AGENDA PORTLAND PLANNING BOARD MEETING

The Planning Board will hold a remote meeting on Tuesday, February 23, 2021, 4:30 p.m. This meeting will take place using Zoom.

Memorandum

To: Chair Mazer & Members of the Planning Board
From: Andrew Tufts, Planner
Date: February 19, 2021
Re: 387 Commercial Street Development
Project ID: PL-001348-2020
Meeting Date: February 23, 2021
CBL: 042 A002001

SHEET 3 OF 11

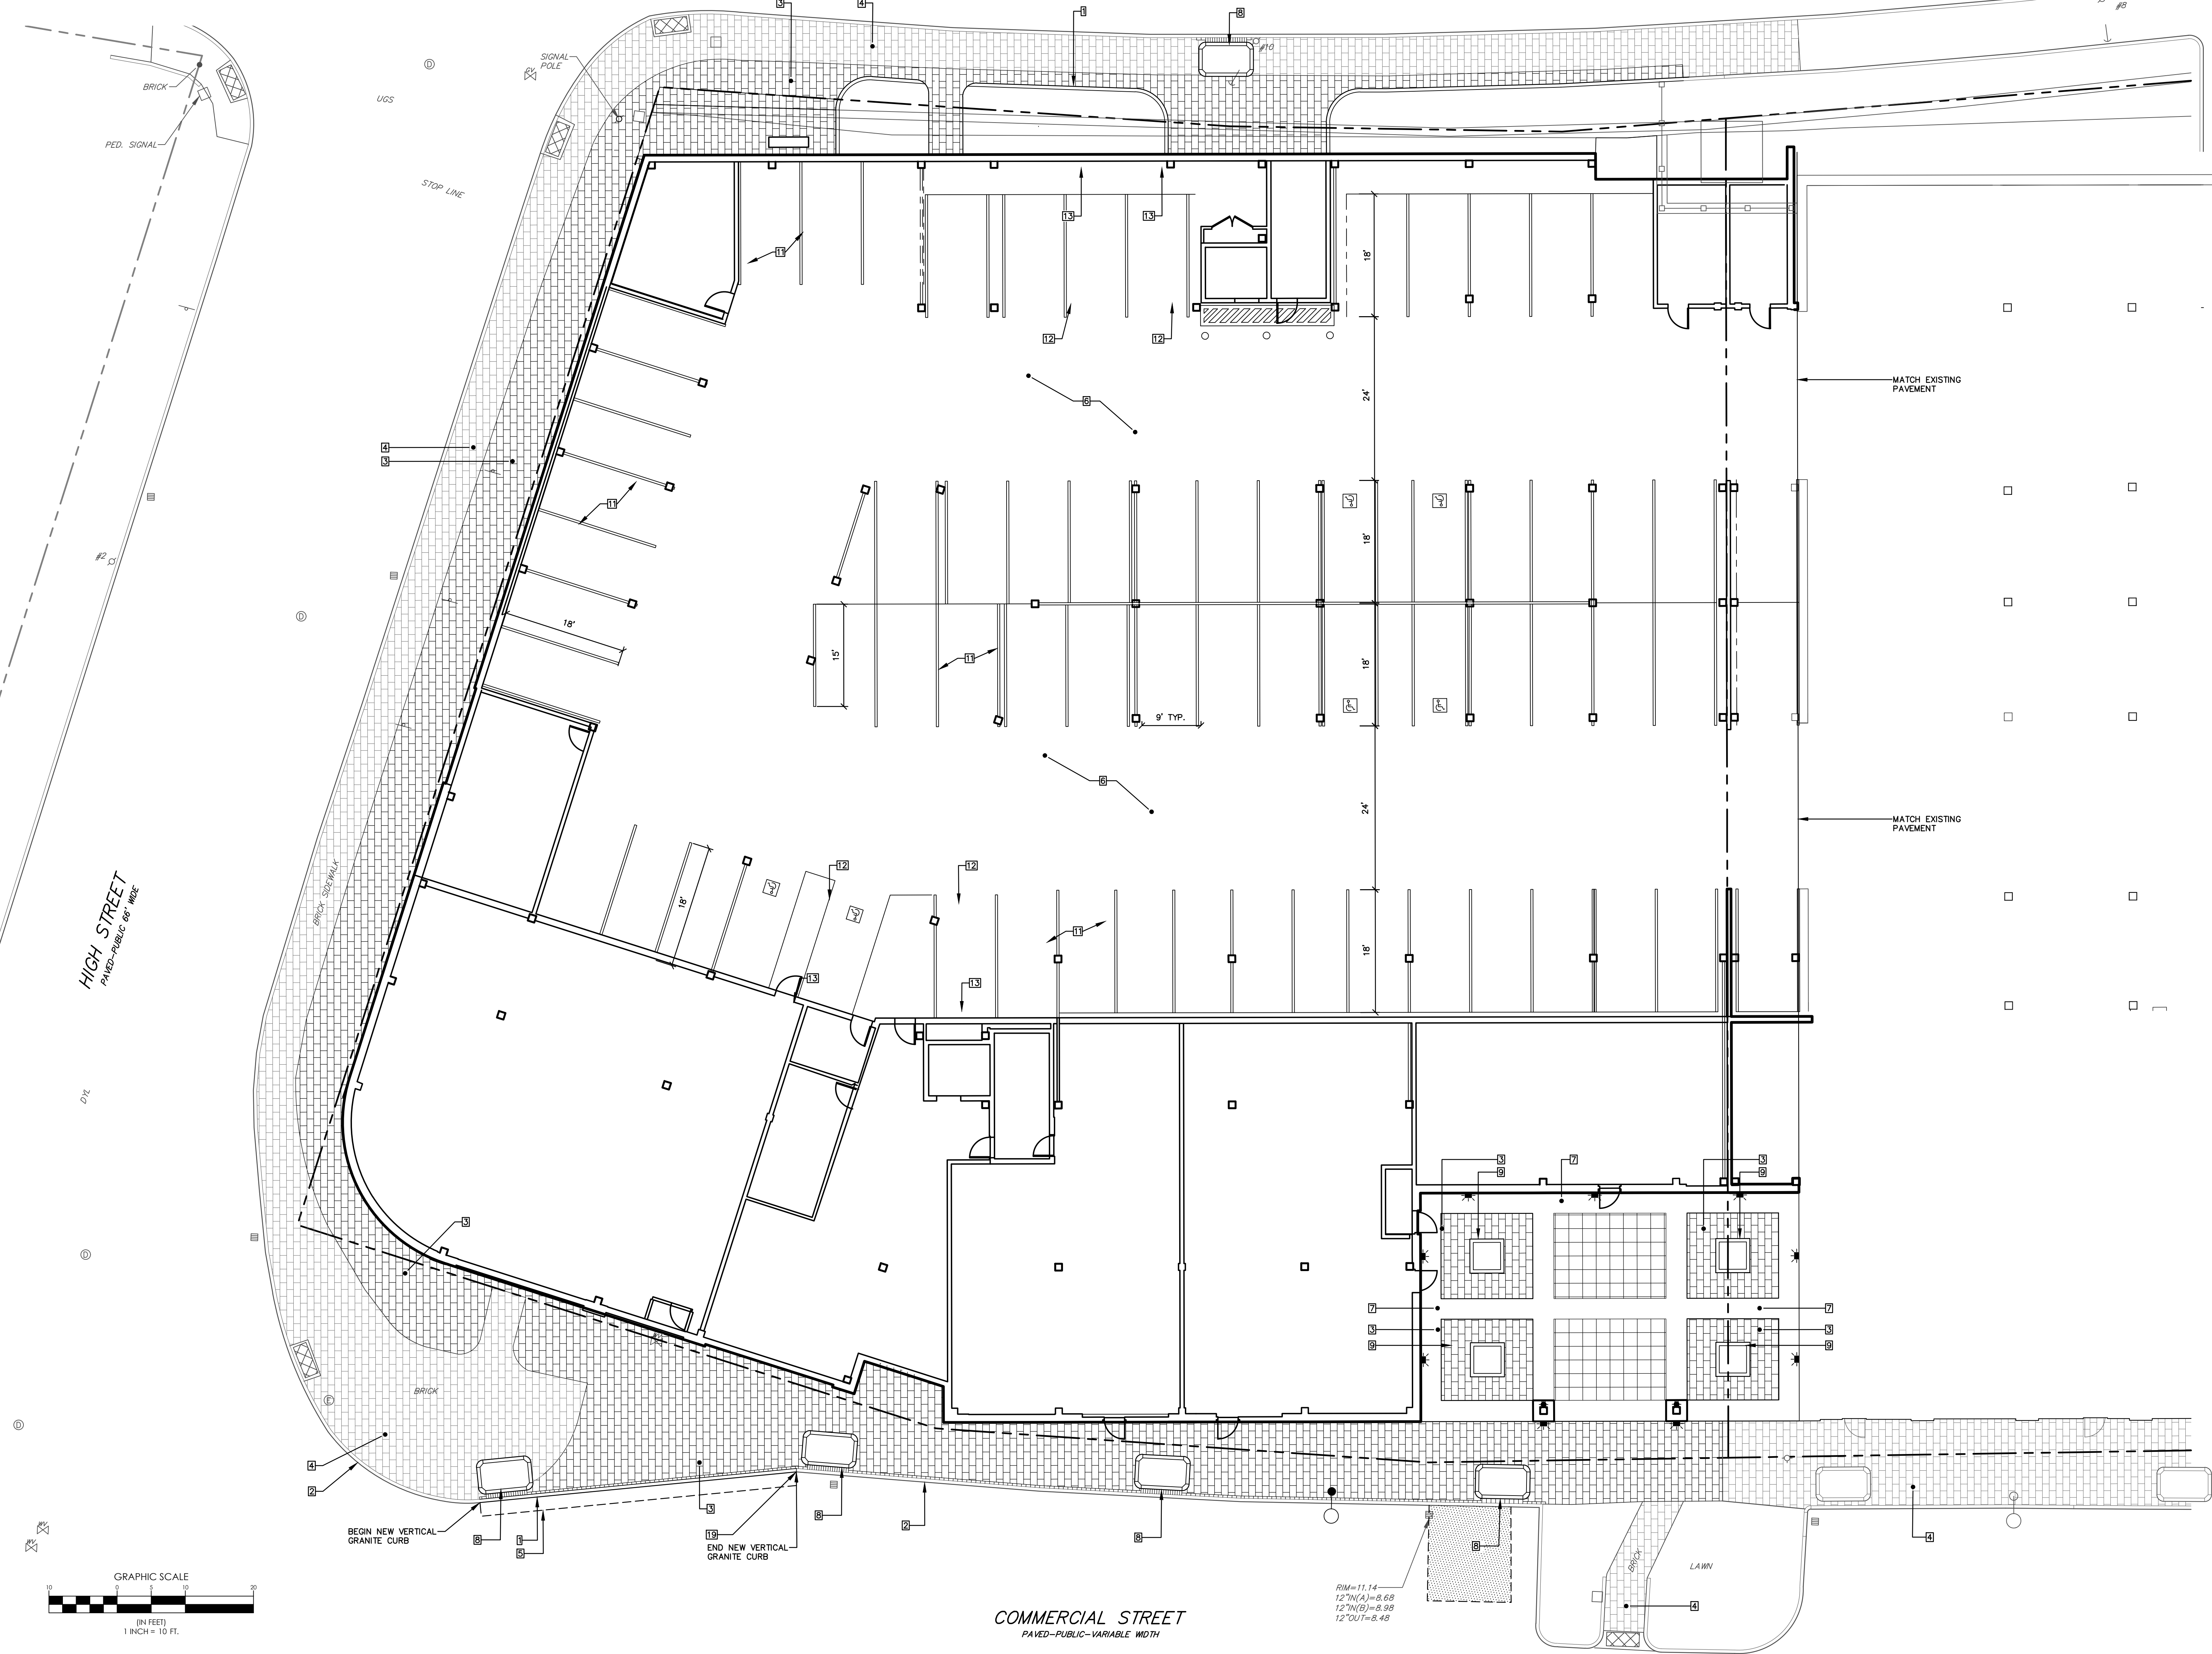
A review of the most recent site plan (Civil Sheet 03) for Phase III frontage of Hobson's Landing (PL1348-2020) shows that the design does not address a Condition of Approval from the Master Development Plan. That condition calls for the frontage to facilitate the West Commercial Street Pathway's extension to the enhanced crossing (curb extensions, refuge island and RRFB flashing beacons which is mid-block on its frontage).

- *The Applicant should show on the site plan where loading and delivery activities for the site will occur, as well as solid waste pick-up.*
- *The site plan indicates that brick sidewalks will only be partially rebuilt on all three frontages, and that some existing sidewalk will remain. It is unlikely that brick sidewalks adjacent to staging and laydown areas will remain in good condition throughout construction. Matching existing and new brick walkways may prove difficult, especially in the vicinity of pedestrian ramps. At the corner of Commercial and High streets, the breaks between new and existing sidewalk are curved and cannot be a realistic depiction of what is expected to be constructed. Breaks in grade along such sidewalks will not be permitted. It is strongly recommended that the Applicant show all new brick sidewalks along all frontages. Otherwise, the site plan should indicate that any damaged or heaved sections of brick sidewalk along the project's frontages shall be reconstructed (regardless of whether the damage was caused by construction activity). It is acceptable to remove and reuse existing bricks that are in good condition.*

- *5-foot x 8-foot tree planters are large, and pinch the available sidewalk space to undesirable levels in some locations. The Applicant should work with DPW and Jeff Tarling to determine the appropriate size and material of these tree planters.*

- *One tree planter appears to be located directly in front of the entrances of two of the units in the proposed site. This tree planter should be moved elsewhere to avoid a pinch point where thru pedestrian traffic is not forced to walk through the door-opening zone of the building.*

- *The 5-foot pedestrian path crosses into the project ROW at several locations, typically at tree planters. Sidewalk access agreements will be required.*
- *It is unclear what is being proposed for the area where the existing driveway is being closed. The curb tapers in from a diagonal/perpendicular parking area to the existing curb line. Is this area intended for loading? The applicant should clarify.*

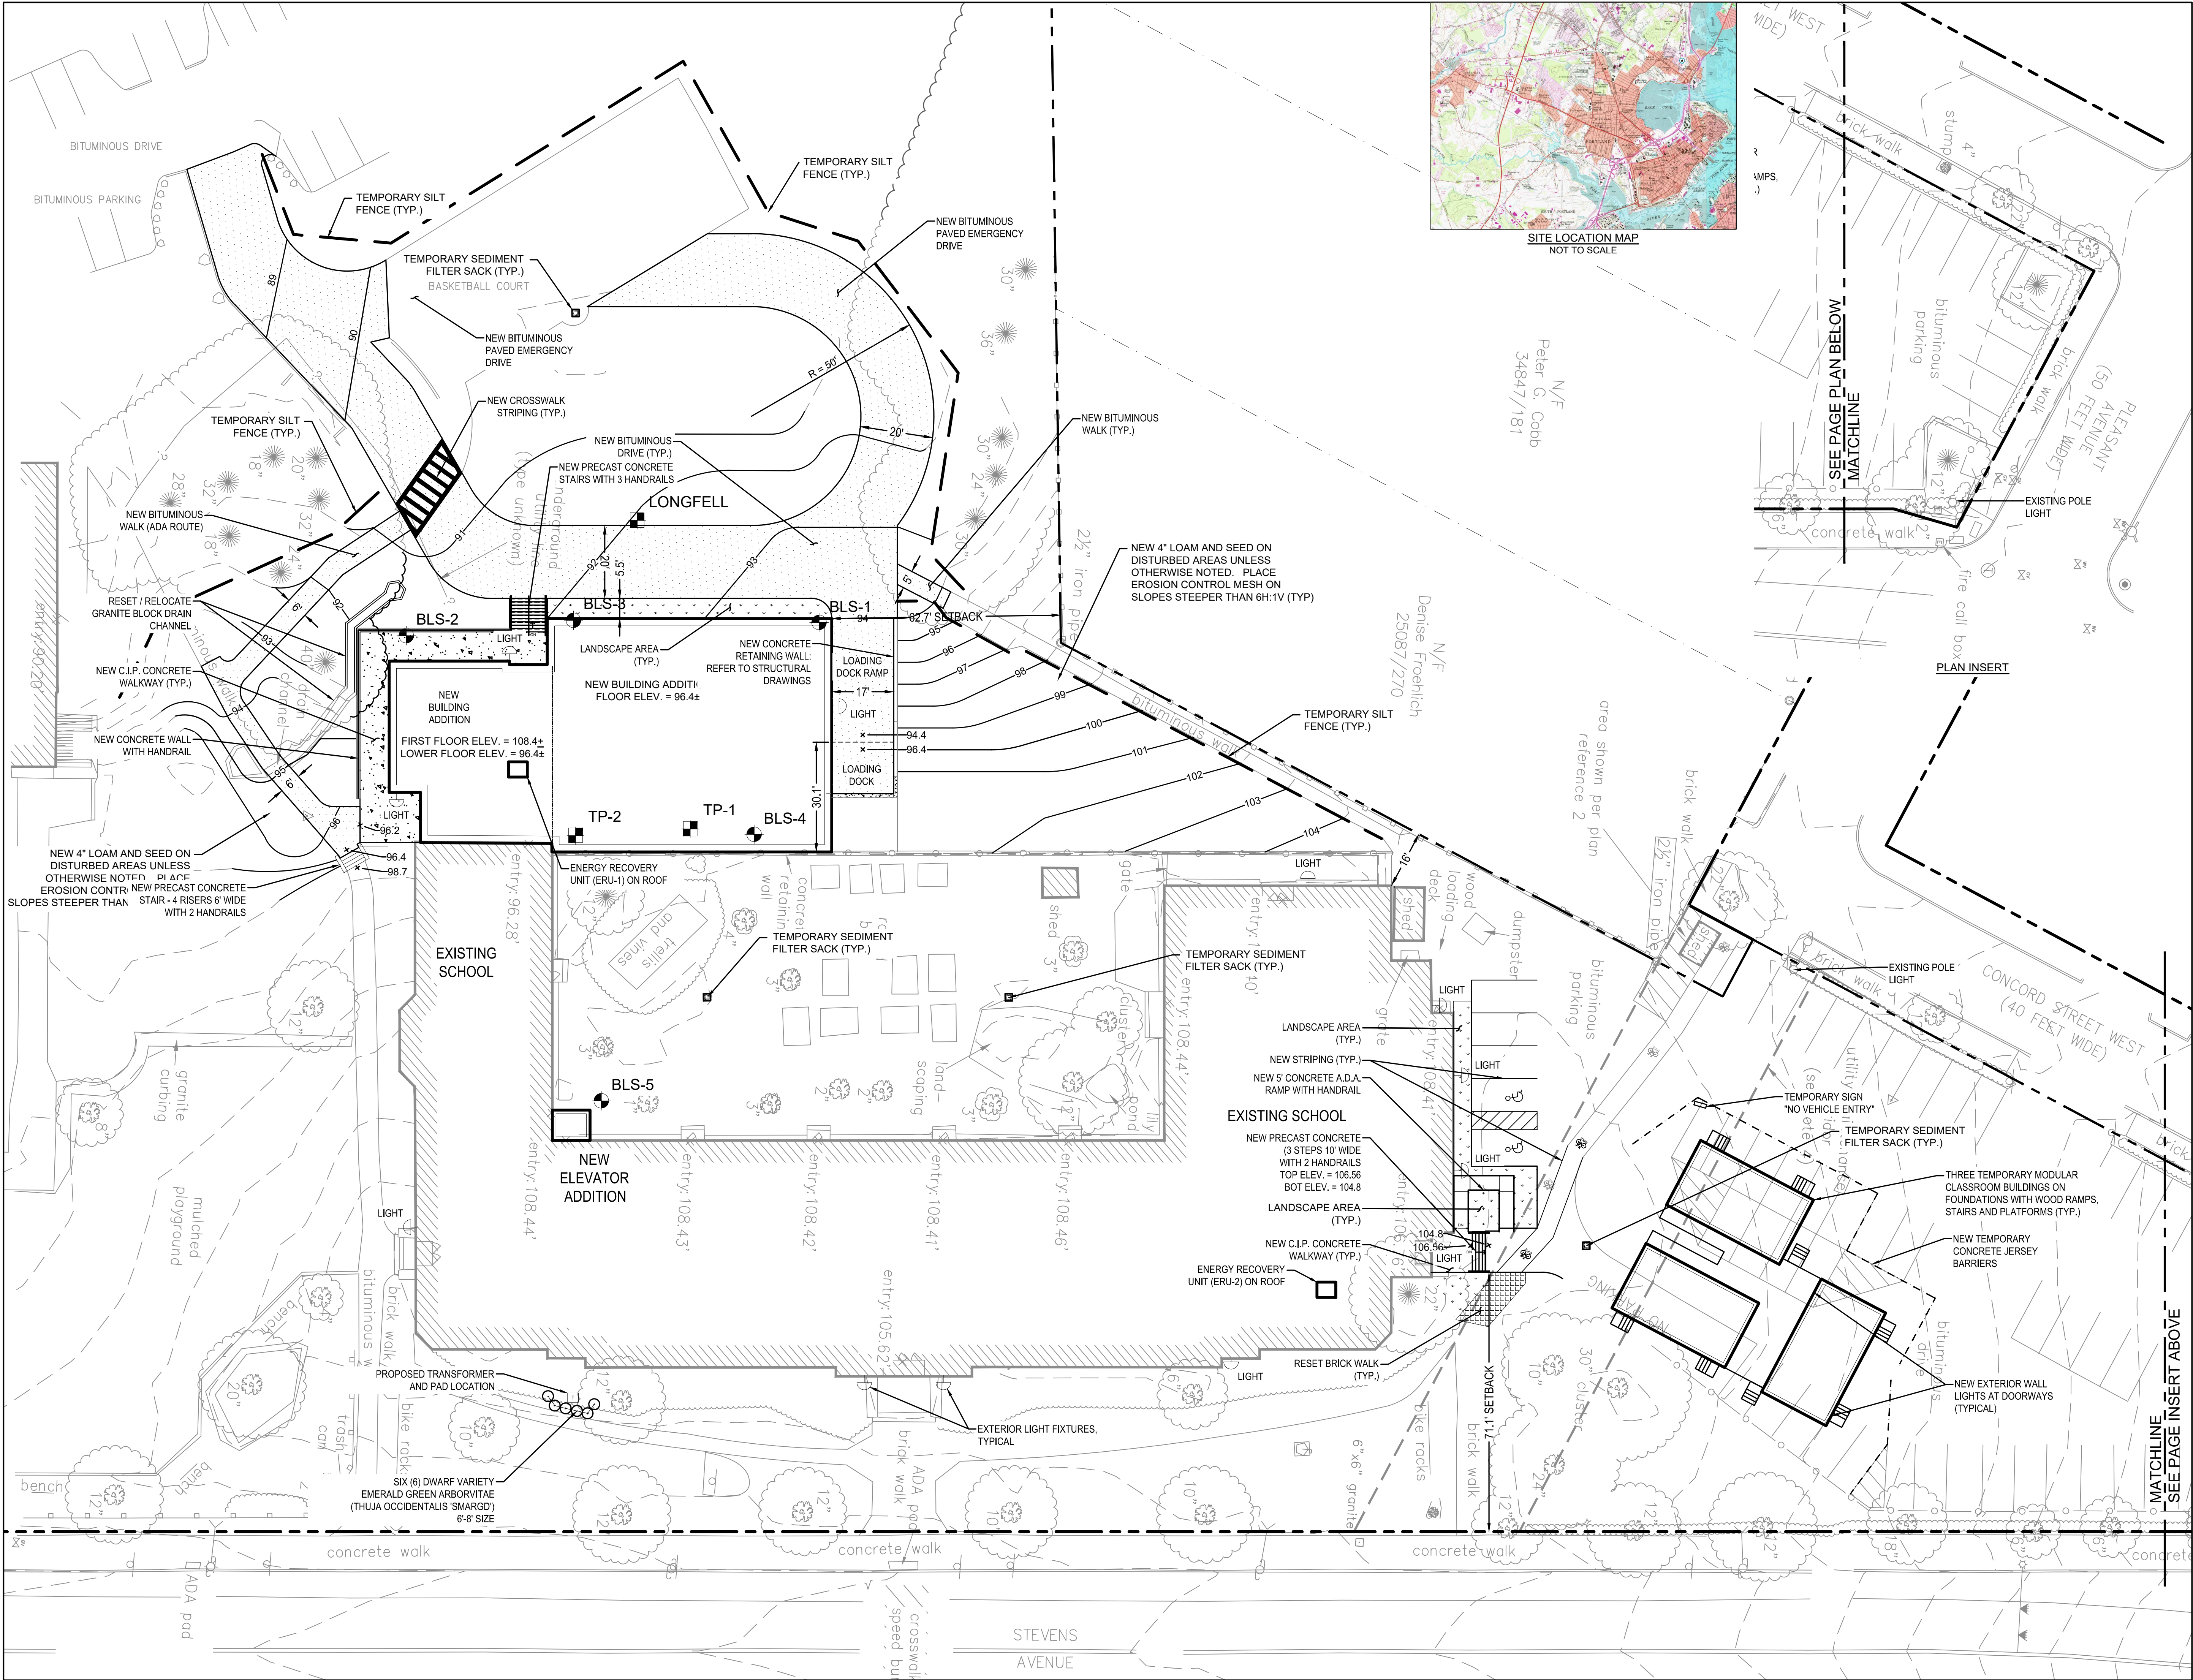
13. Two new heat recovery units(HRU-1 and HRU-2) are shown on the roof of the existing school and the new addition, on attached revised drawing C00-1 Site Plan. The unit catalogue sheet is attached in the original submission in Exhibit 21 – Noise and Vibration. The units are both the same size and are only 3'-8" tall and set back at least 15' from the existing roof edge, and therefore, should not be objectionable from public streets or nearby sites. No separate screening is proposed.

15. There are no existing site light poles in the parking lot to the north of the building. However, City light poles on the adjacent streets shed sufficient light for the parking lot. The City street light pole on the corner of Pleasant Street has a spotlight aimed to light the parking lot. And there is a light fixture on the pole on the corner of Concord Street West and the school access drive, aimed into the lot. These existing light poles have been added to drawing C00-1 Site Plan. Proposed building-mounted site light fixture locations are also shown on the attached revised C00-1 Site Plan.

18. The modular units will have wall-mounted porch lights at exterior doors for security.
19. The existing parking lot striping will be retained and re-painted, once the modular classroom units are removed from the site. The parking lot will be returned to existing condition as shown on drawing C10-1, as originally submitted. This project does not have a second phase.
20. Distances to adjacent property lines from the existing and proposed buildings are shown on the attached revised C00-1 Site Plan.
